# SERVICE BULLETIN

B-097

## BUELL 2009 XB12Ss SAFETY RECALL 0839

Figure 1. P-clamp Installed at 180 Degrees

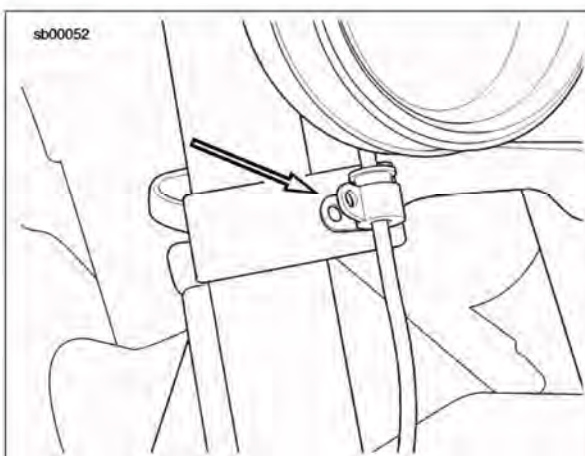
1. Remove the brake line P-clamp fastener on the lower fork clamp.
2. Remove the P-clamp from the brake line grommet.
3. See Figure 1. Turn the P-clamp around and install over the grommet at 180 degrees from its original position.

Figure 2. Front Brake Line Guide over P-clamp

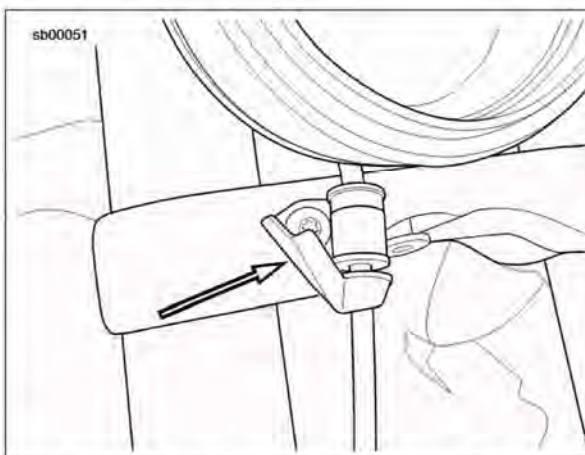
4. See Figure 2. Install the front brake line guide over the top of the P-clamp and install onto the lower fork clamp with the fastener.
5. Tighten the fastener to 36-60 in-lbs (4-7 Nm).
6. See Figure 3. Install the cable strap around the fork tube and brake line between the upper and lower fork clamps just below the turn signal.
7. Cut the excess cable strap and rotate the end to a point behind the headlamp module.

Figure 4. Reflector/Rhino Tape Locations

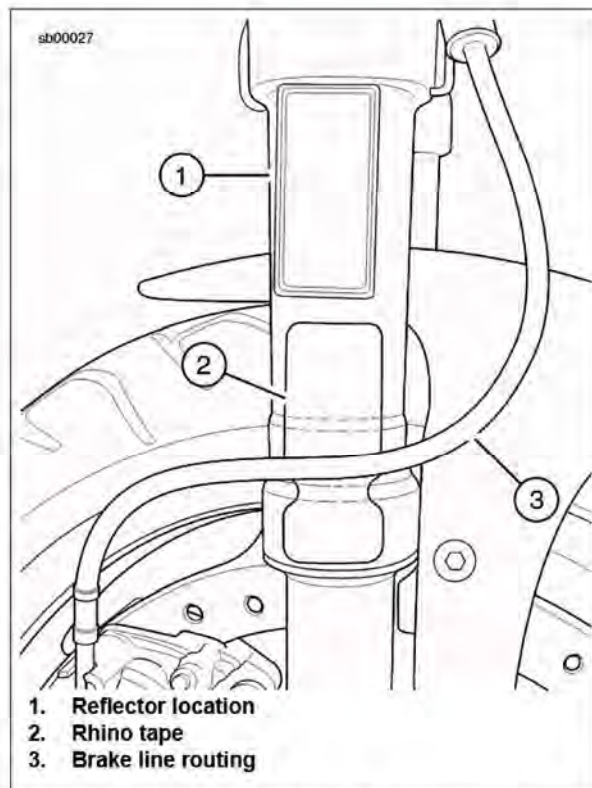
1. Remove and discard the reflectors on the outer fork tubes.
2. See Figure 4. Install the **new** reflectors (1) pressed up against the lower triple clamp.

Figure 5. Front Brake Line Guide

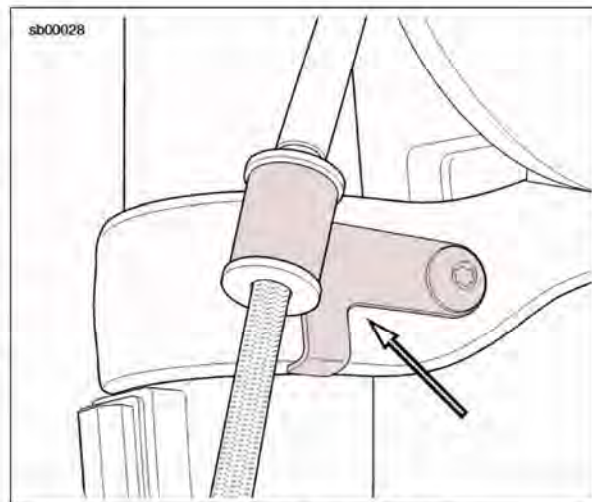
4. Remove the banjo bolt at the master cylinder/reservoir. Discard the copper washers.
5. Remove the banjo bolt at the front brake caliper. Discard the copper crush washers.
6. Remove the upper P-clamp from the headlamp module and the lower P-clamp from the fork clamp. Discard the brake line.
7. Fit the rhino tape (2) against the lower edge of the outer fork tube and press into place.
8. Route the **new** brake line (3) behind the headlamp module and around the outside of the front fork along side the rhino tape.
9. Install both banjo bolts with **new** copper crush washers. Tighten to 16-20 ft-lbs (22-27 Nm).
10. Install the upper P-clamp to the headlamp module and tighten to 36-60 in-lbs (4-7 Nm).
11. See Figure 5. Install the front brake line guide and tighten to 36-60 in-lbs (4-7 Nm). Fill and bleed the front brake. See the service manual.
